BEFORE THE HON'BLE NATIONAL GREEN TRIBUNAL,
WESTERN ZONE BENCH, PUNE
APPEAL NO. 05 / 2025

Union of India & Ors. ... Respondents

REPLY AFFIDAVIT BY RESPONDENT NO. 2,
STATE ENVIRONMENT IMPACT ASSESSMENT AUTHORITY

COMPLIANCE POINT NO 5: PP to submit the Hydraulics study or effect of RFD on natural storm water disposal into Mula- Mutha river.

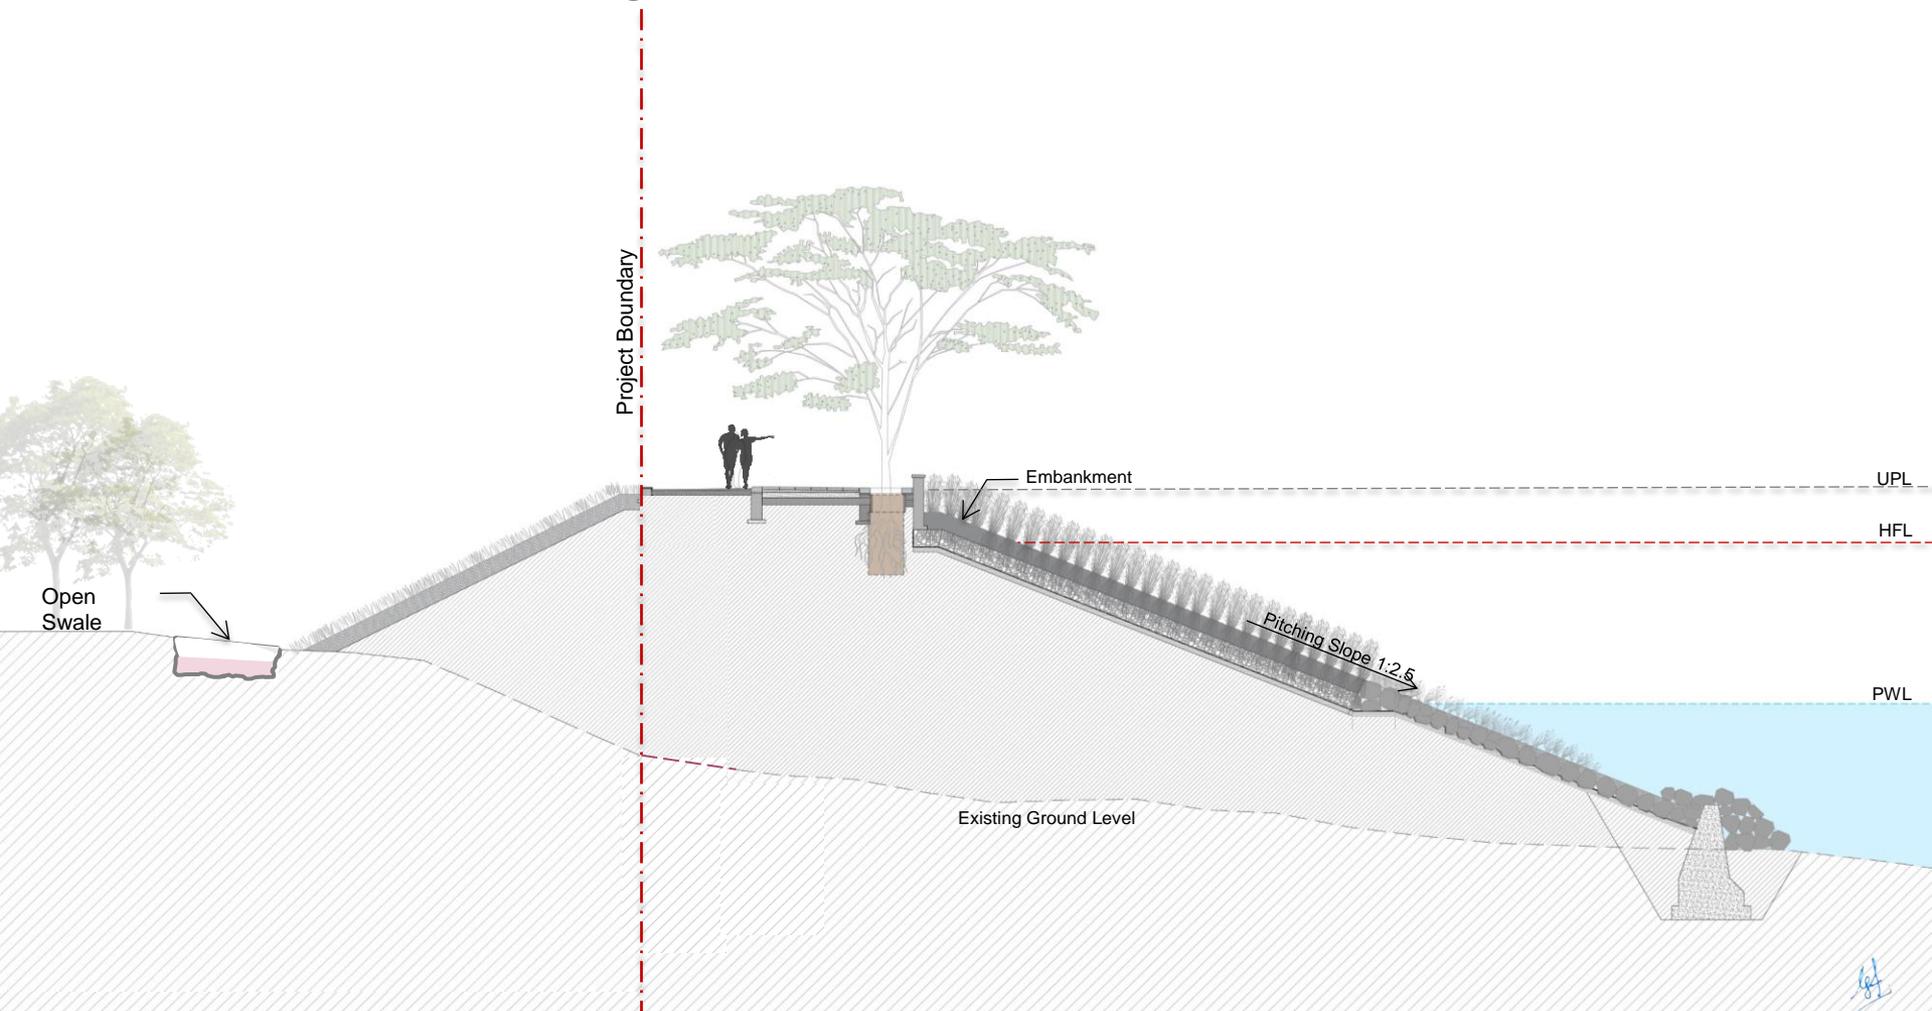
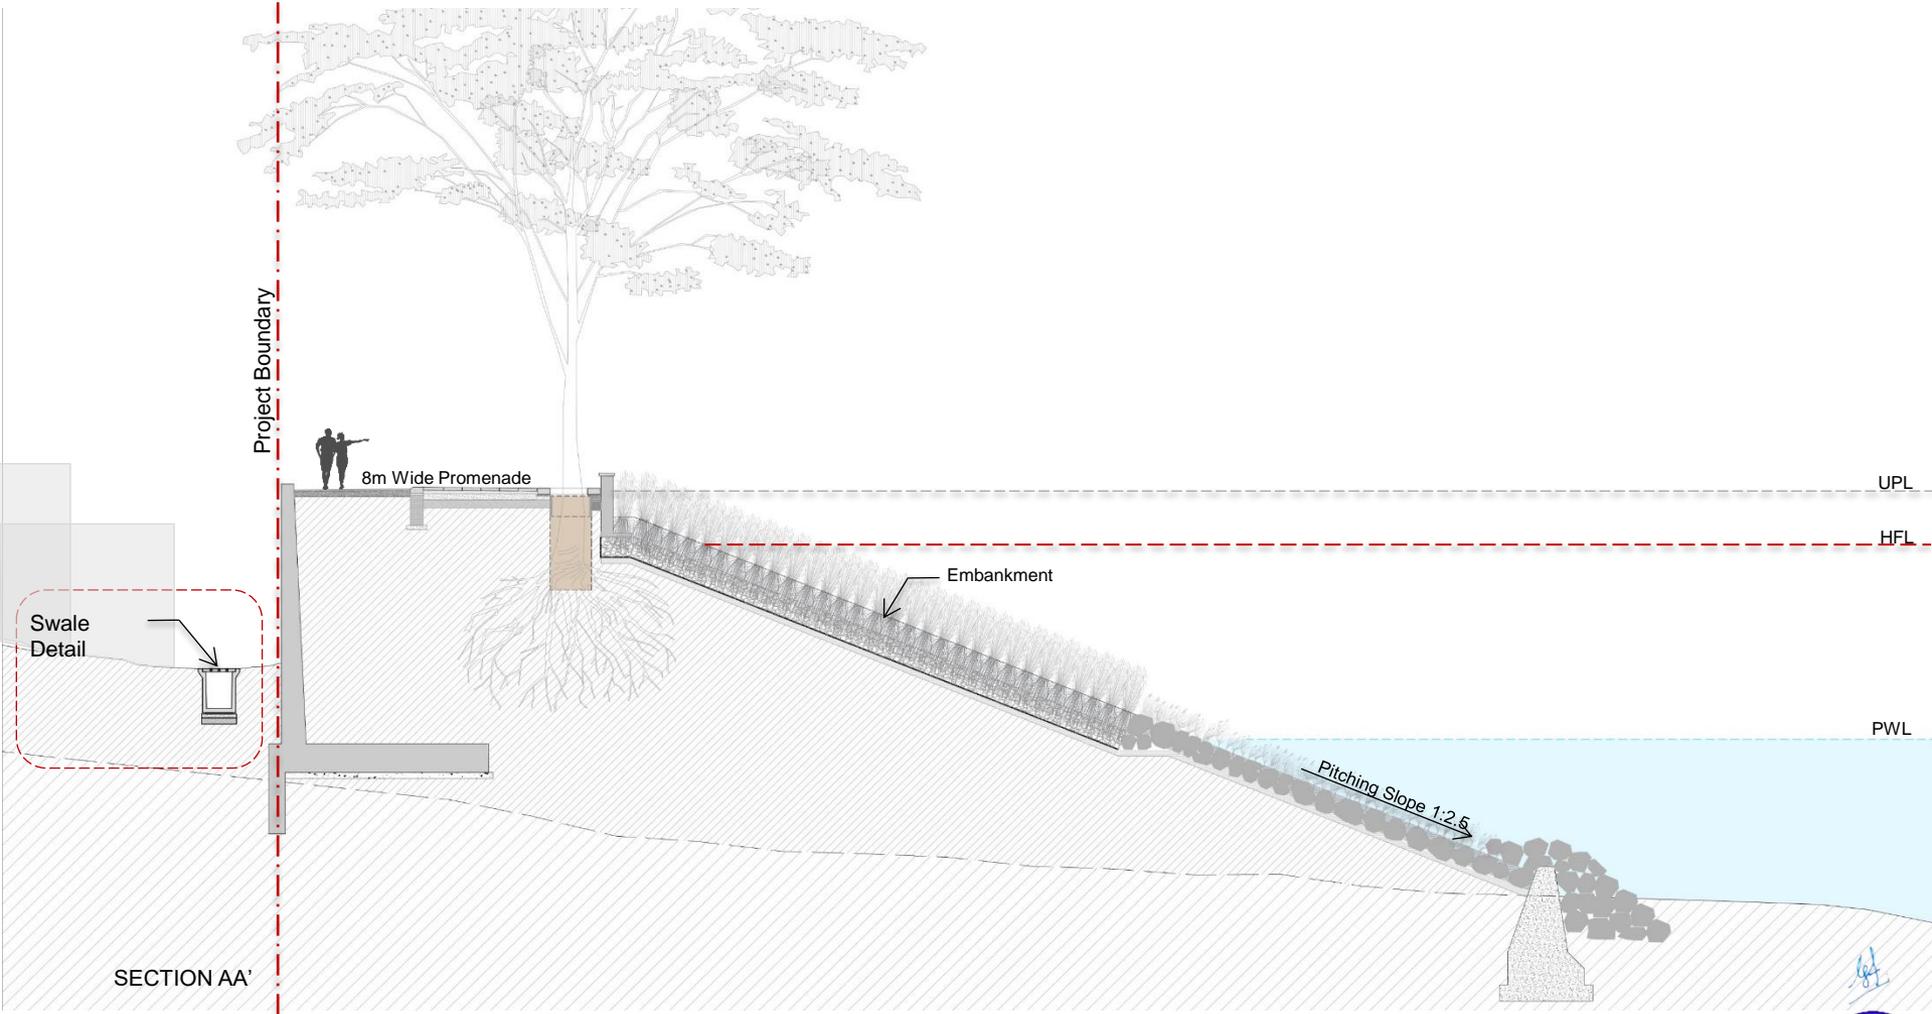
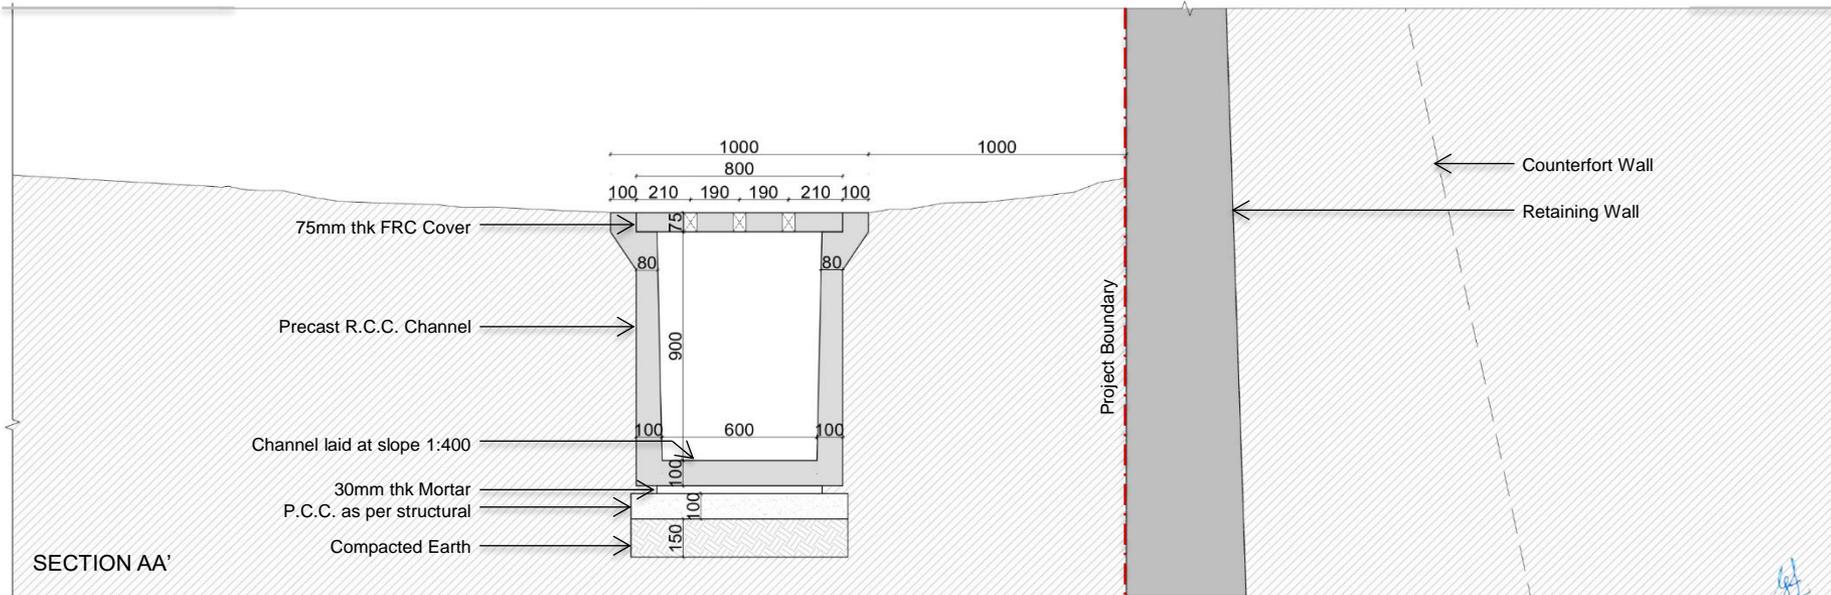
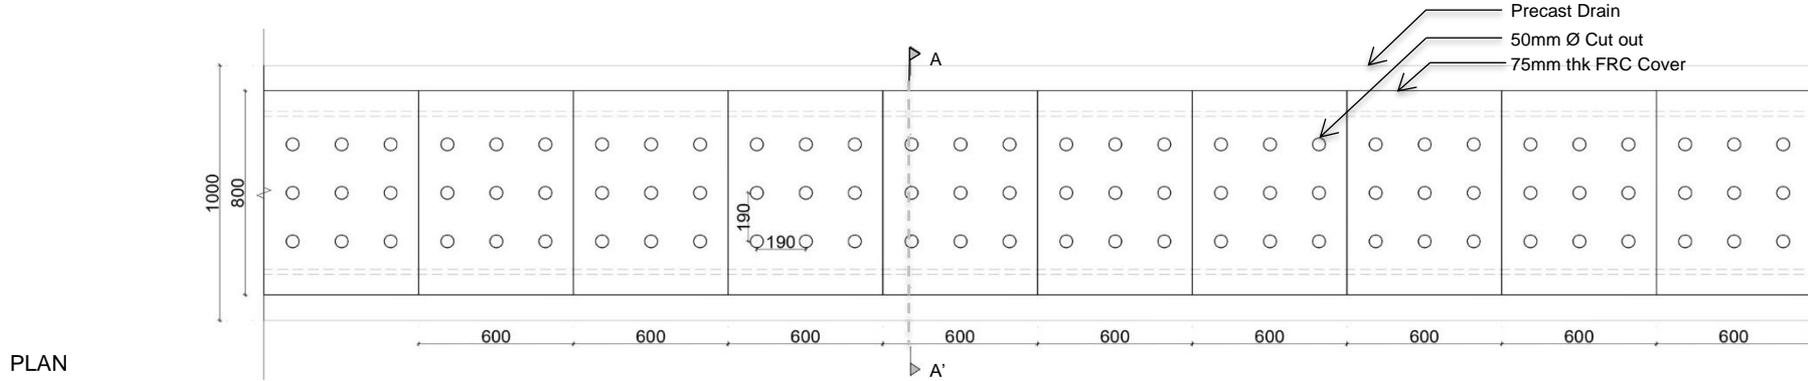
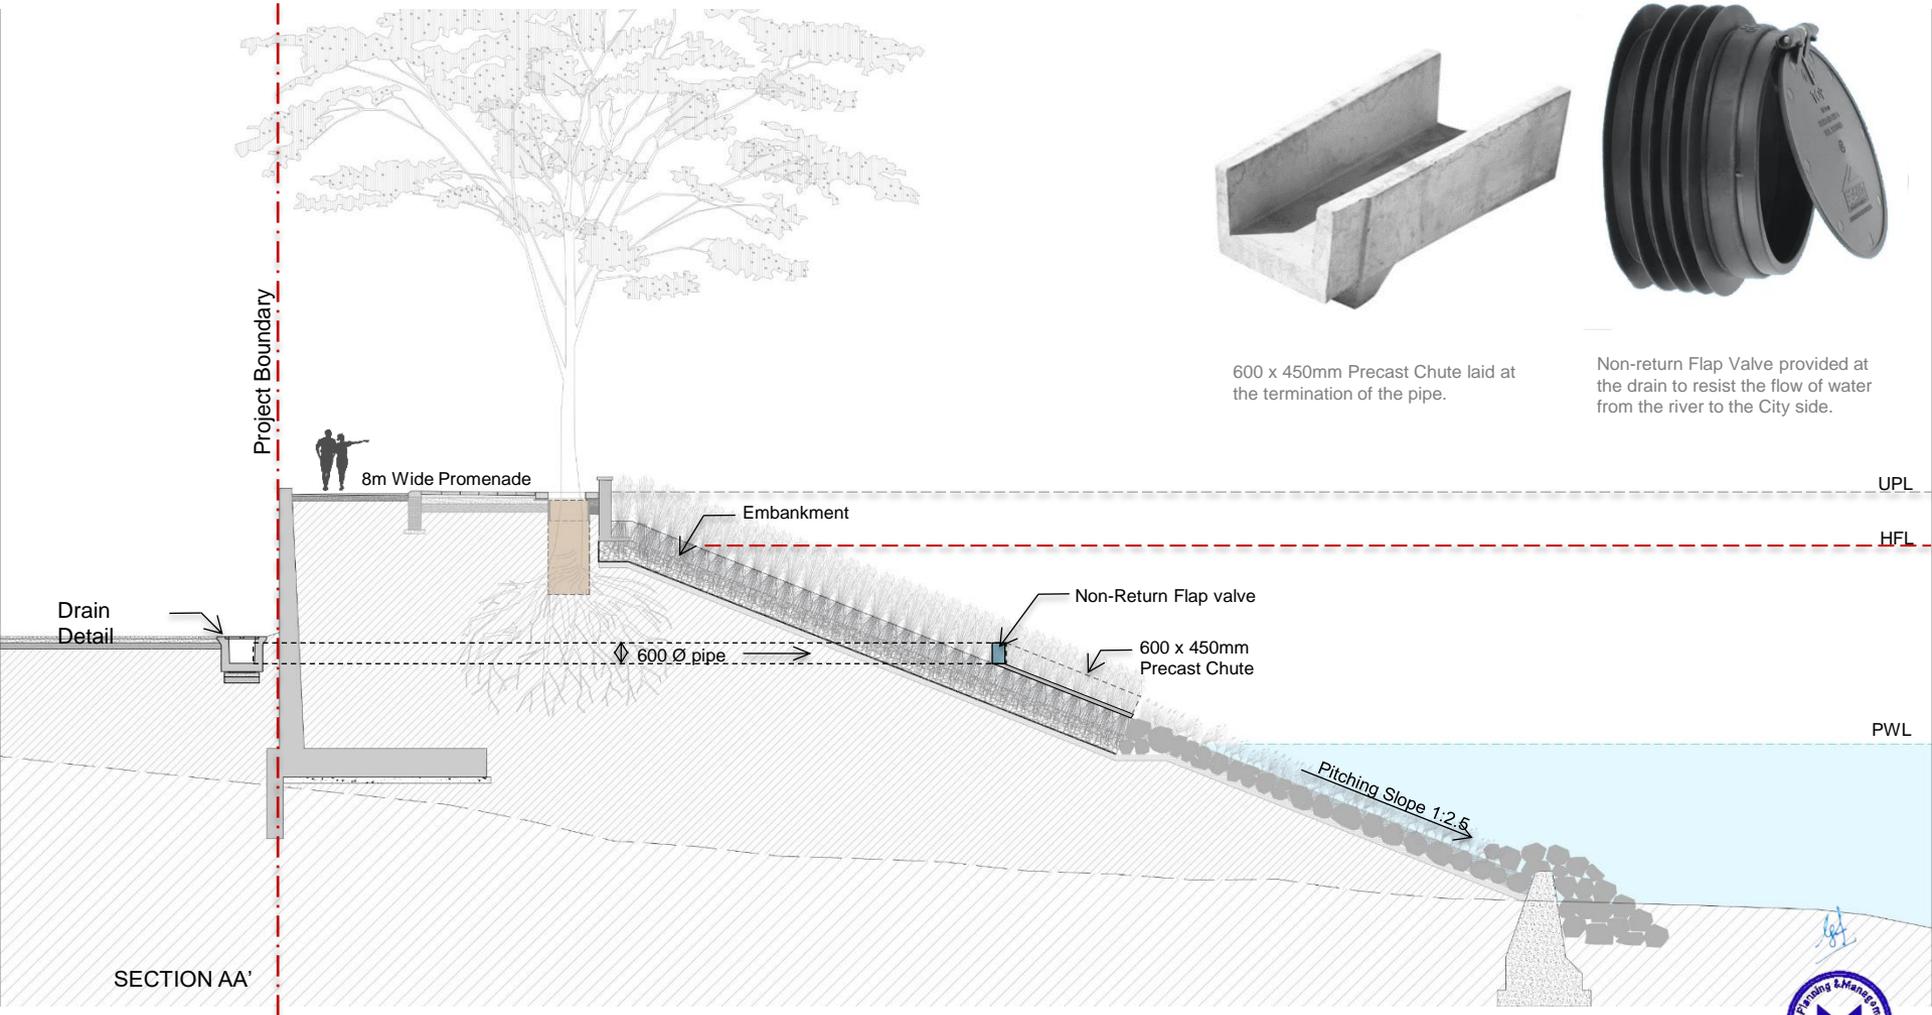
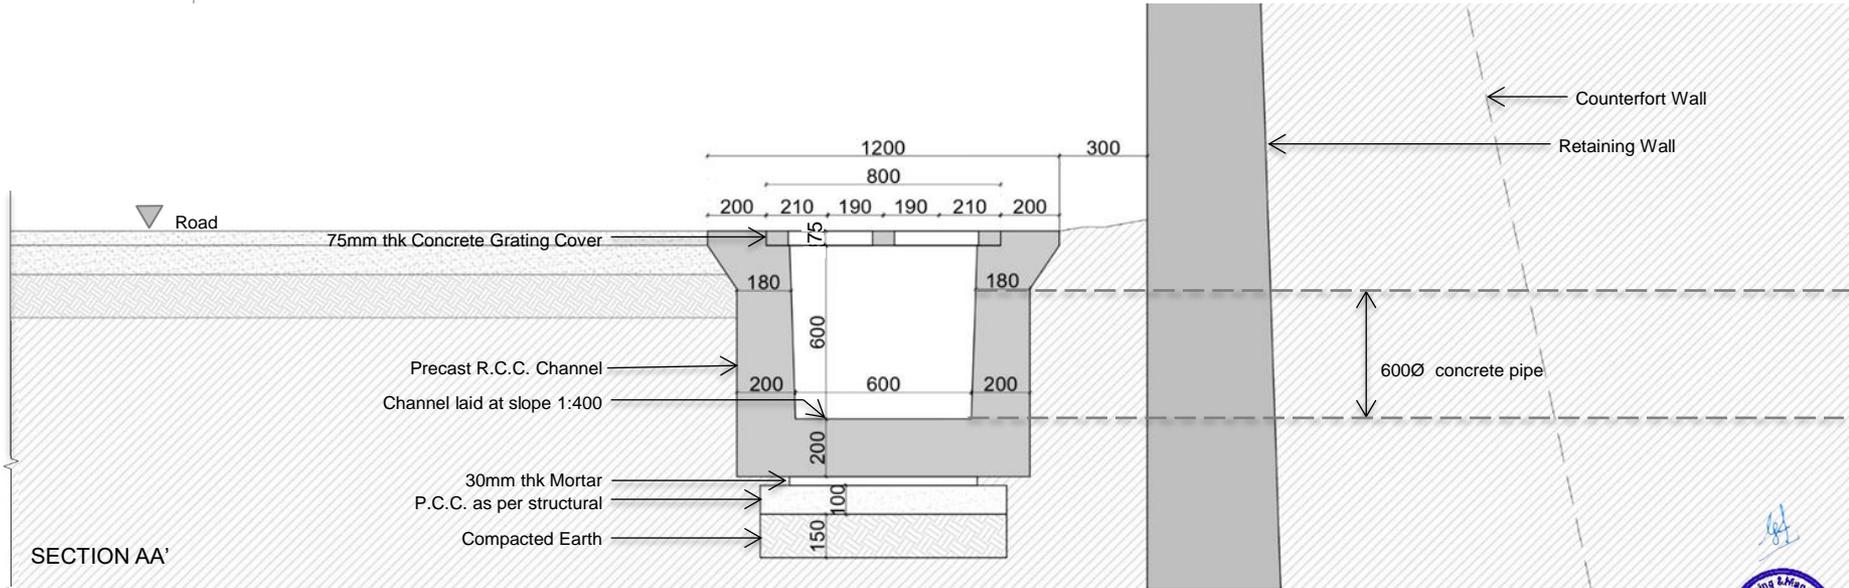
g. However, during the flood in river, retention of flood within nallah shall be ensured to avoid submergence of urban areas due to backwater effect.

f. Those stretches will be provided with swales running parallel to the embankments along the city side up to the next nallah or would have provisions of outfalls at strategic locations. The locations and dimensions of these swales would be finalized during the detailed design stage.

Open Swale provided along the back slope of the embankment

Closed Swale Detail near residential areas

600 x 450mm Precast Chute laid at the termination of the pipe.

Non-return Flap Valve provided at the drain to resist the flow of water from the river to the City side.
